UNITED STATES PATENT AND TRADEMARK OFFICE

APPLICATION NO.	FILING DATE	FIRST NAMED INVENTOR	ATTORNEY DOCKET NO.	CONFIRMATION NO.
10/538,063	06/09/2005	Christophe Martinez	007875-0316315	8903

Office Action Summary

DETAILED ACTION

Figure 8

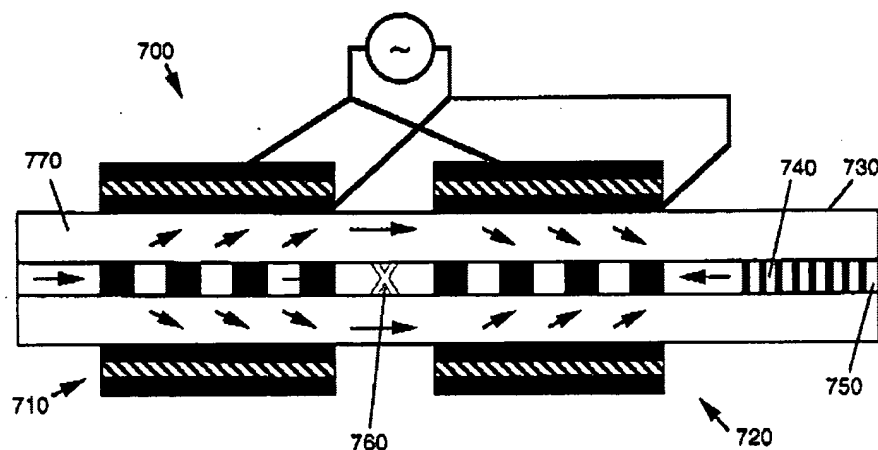
In re claims 1 and 11, Starodubov discloses a sampling device 700 comprising:

a substrate (the electro-sensitive layer shown in Fig. 8);

a waveguide core 750 in the substrate, the waveguide core being configured to transport a light wave;

an optical cladding 770 in the substrate, wherein at least a portion of the cladding surrounds at least a portion of the core in a zone of interaction 710/720,

said zone 710/720 comprising a grating configured to couple, in the cladding, a part of the light wave to form a coupled wave,

wherein a refractive index of the cladding is different from a refractive index of the substrate and the refractive index of the cladding is lower than a refractive index of the core at least in a part of the cladding adjacent to the core in the zone of interaction (e.g., see columns 4-6). Figure 8 of Starodubov is reproduced below.

In re claims 2, 3, 5, 6 and 9, elements 740 and 760 of Starodubov meet the specified limitations.

In re claim 14, the zone of interaction 710/720 of Starodubov is inherently capable of performing filtering and sampling because it comprises the same claimed structural features.

FIG. 2

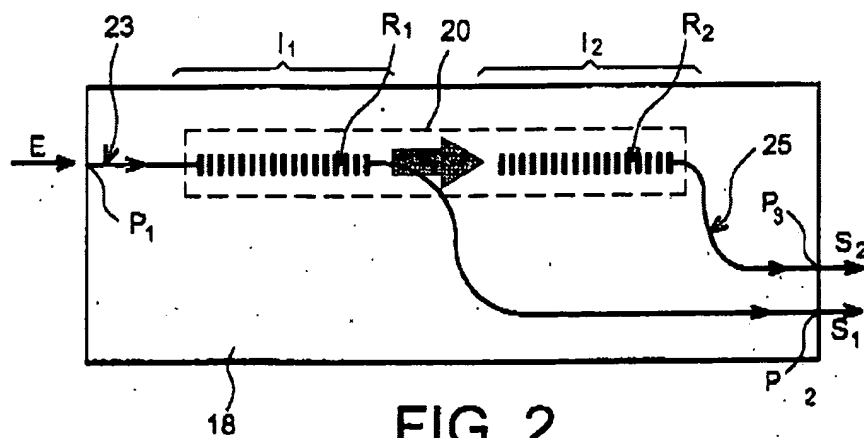
In re claims 1 and 11, Martinez discloses a sampling device (e.g., Figures 2-7) comprising:

a substrate 18;

a waveguide core 23/25 in the substrate, the waveguide core being configured to transport a light wave;

an optical cladding 20 in the substrate, wherein at least a portion of the cladding surrounds at least a portion of the core in a zone of interaction I1/I2,

said zone I1/I2 comprising a grating R1/R2 configured to couple, in the cladding, a part of the light wave to form a coupled wave,

wherein a refractive index of the cladding is different from a refractive index of the substrate and the refractive index of the cladding is lower than a refractive index of the core at least in a part of the cladding adjacent to the core in the zone of interaction (e.g., see ¶¶ [0088]-[0096]). Figure 2 of Martinez is reproduced below.

In re claims 2-9, 11, 14, and 30 the recited limitations are clearly disclosed by Martinez with respect to Figures 2-7.

FIG. 3**Conclusion**

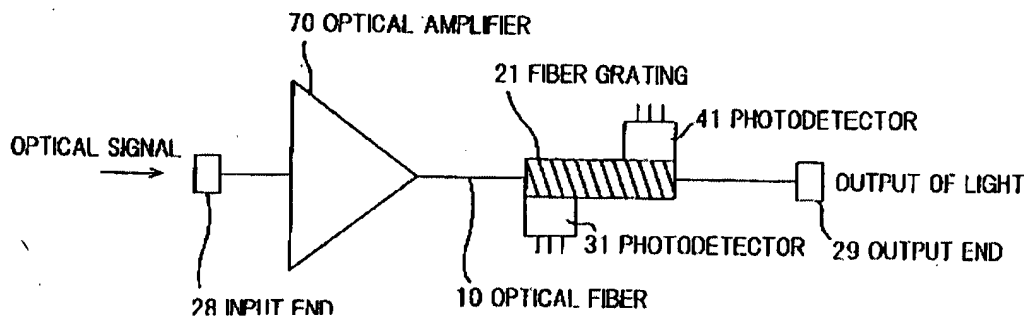
In re claims 10, 12, and 13, Starodubov only differs from these claims in that Starodubov does not teach a photodetector, formatting element, and an amplifier as claimed. Saeki, on the hand, teaches a photodetector 31/41 and an amplifier 70 as recited by claims 10, 12, and 13. The "optical amplifier control means" disclosed by Saeki (column 2, lines 43-45) may be considered a formatting element associated with a photodetector as recited by claim 31. The motivation for combining Saeki with Starodubov is to provide for tunable grating in Saeki by using the fiber grating of Starodubov. Therefore, it would have been obvious to one of ordinary skill in the art at the time of the claimed invention to obtain the invention specified by claims 10, 12, 13, and 31. Figure 3 of Saeki is reproduced below.
